**Cajon Valley Union School District
Bid No. 1598
Concrete Projects – Various School Sites**

ADDENDUM No. 1

March 22, 2023

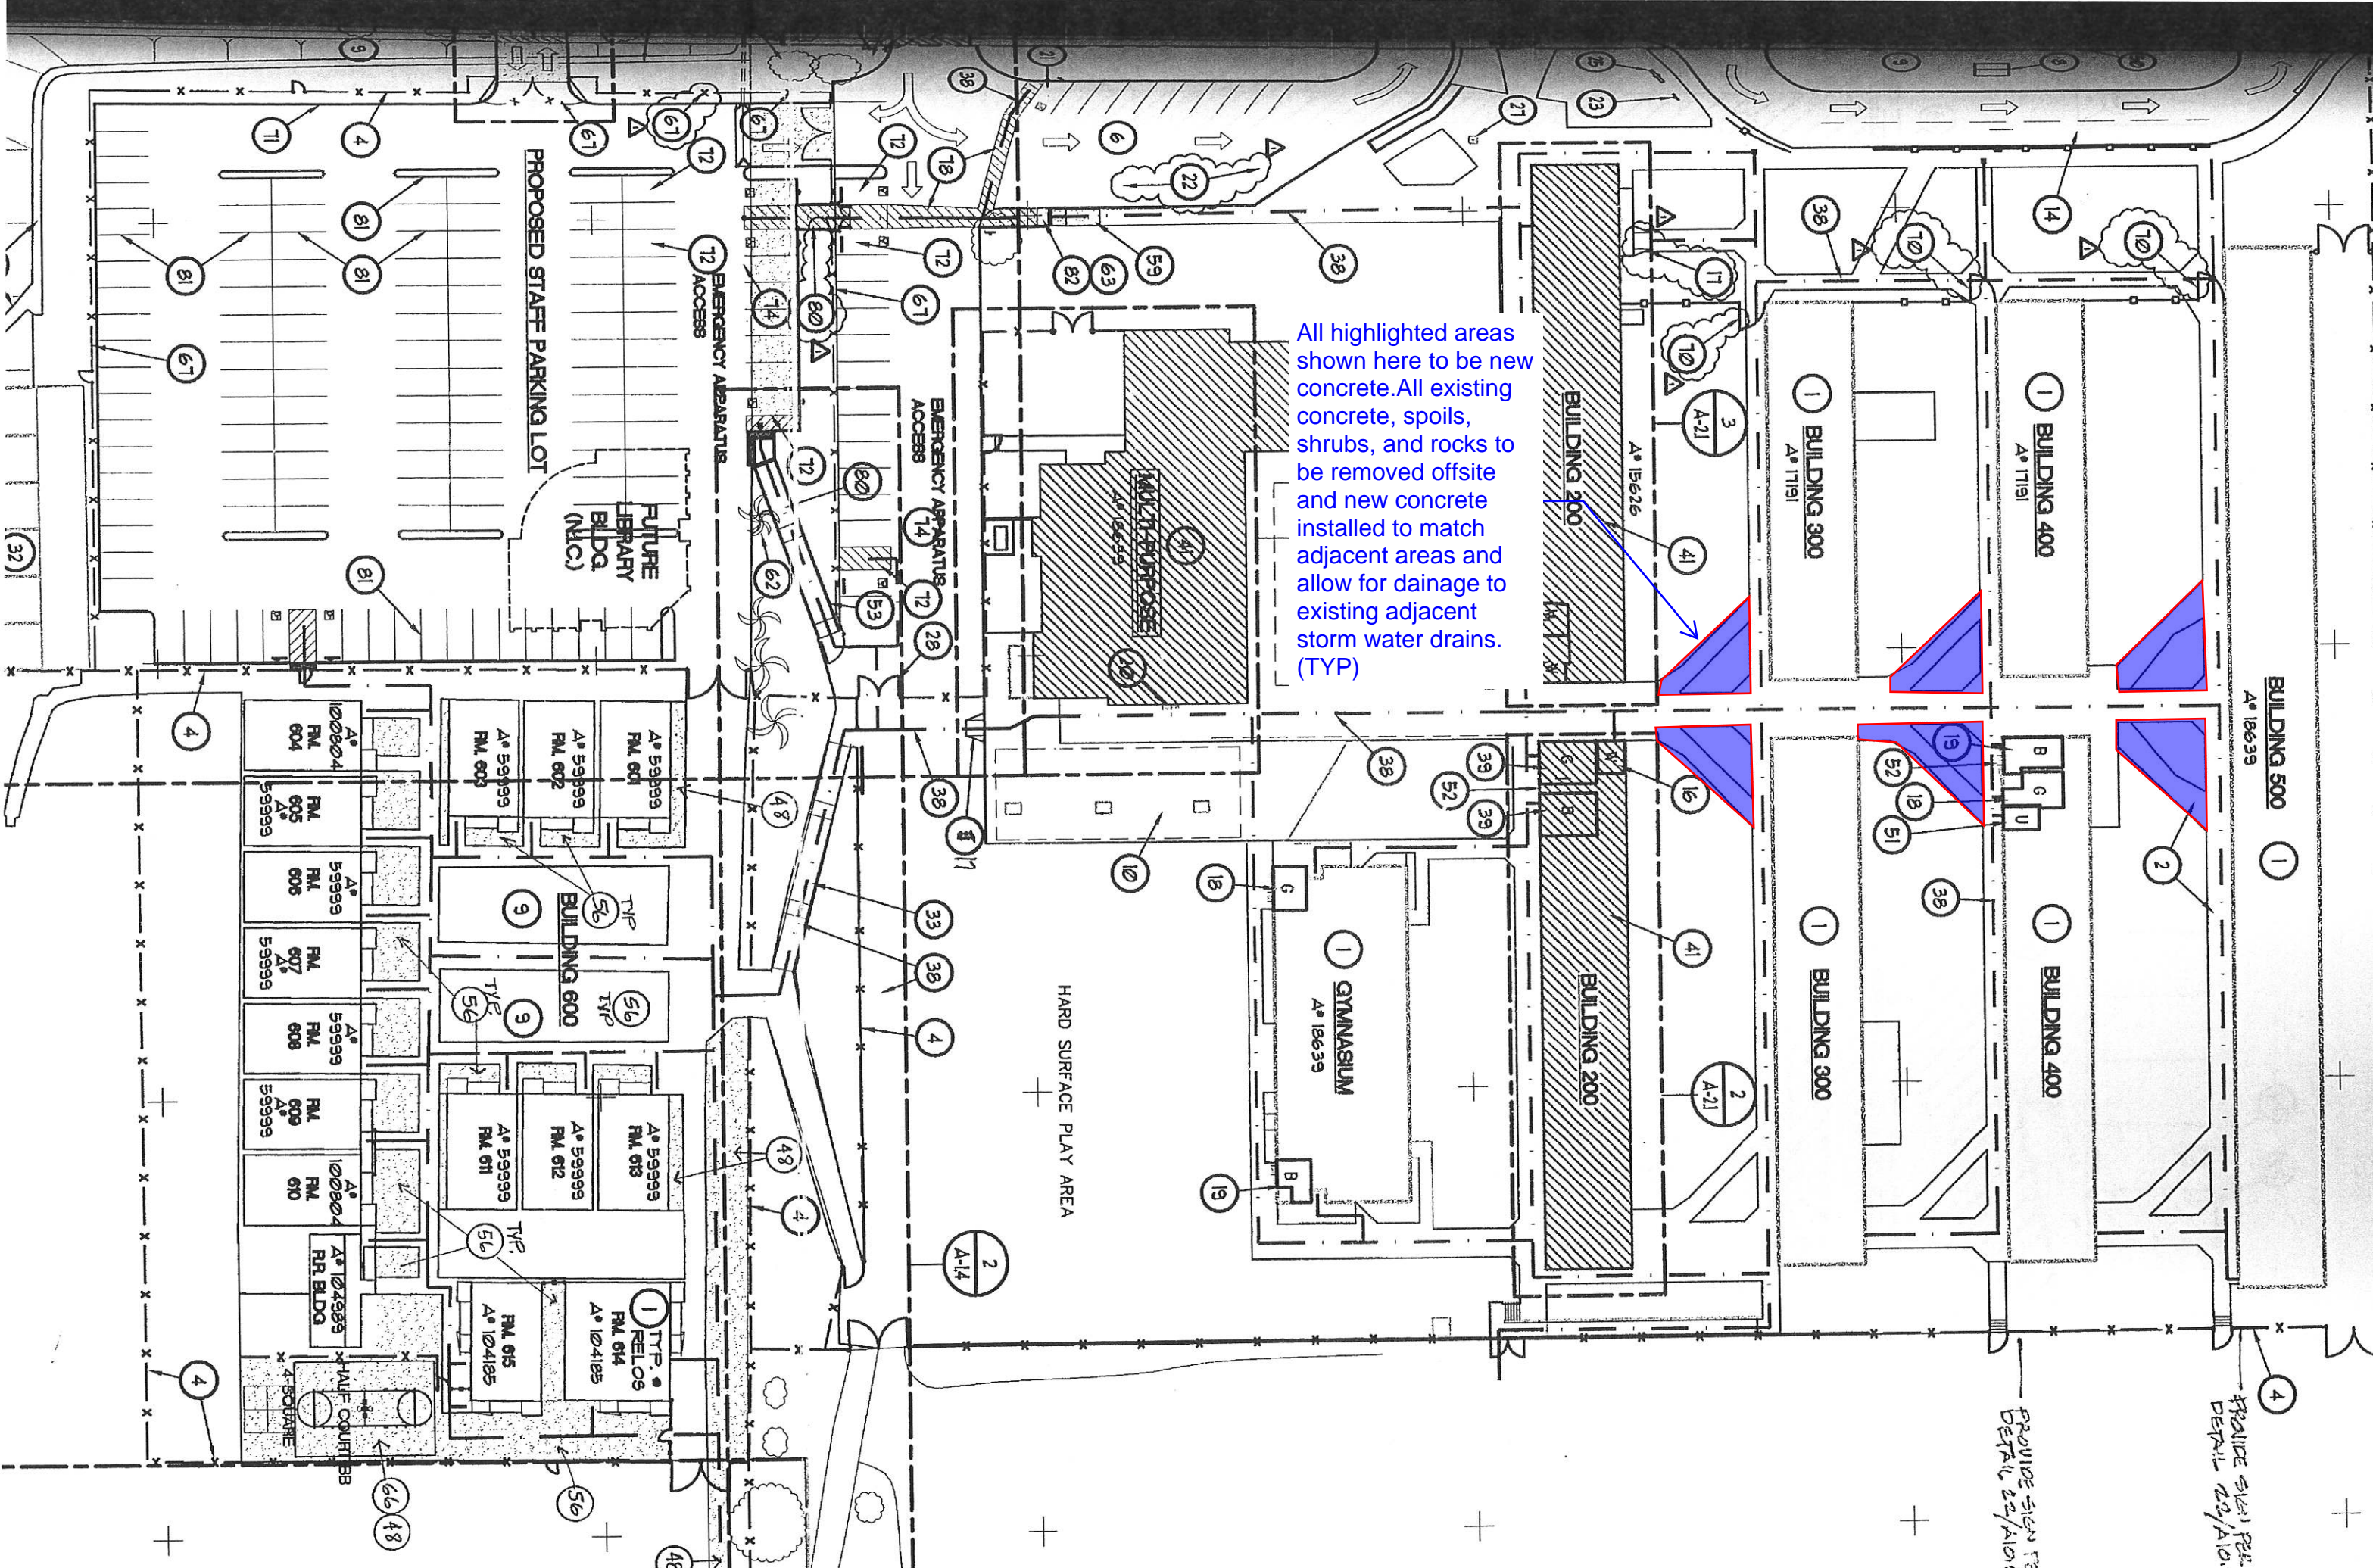
ITEM 1: Bostonia Global High School

For clarification on areas of work at Bostonia Global High School (BGHS) see attached site plan with blue shaded areas for demo of existing and installation of new. All existing concrete, spoils, shrubs, and rocks to be removed from these areas to allow for new concrete to be installed in the entire area shown to match adjacent grades and allow for existing drainage to flow. This does not change or override any of the other specifications within these bid documents.

All highlighted areas shown here to be new concrete. All existing concrete, spoils, shrubs, and rocks to be removed offsite and new concrete installed to match adjacent areas and allow for drainage to existing adjacent storm water drains. (TYP)
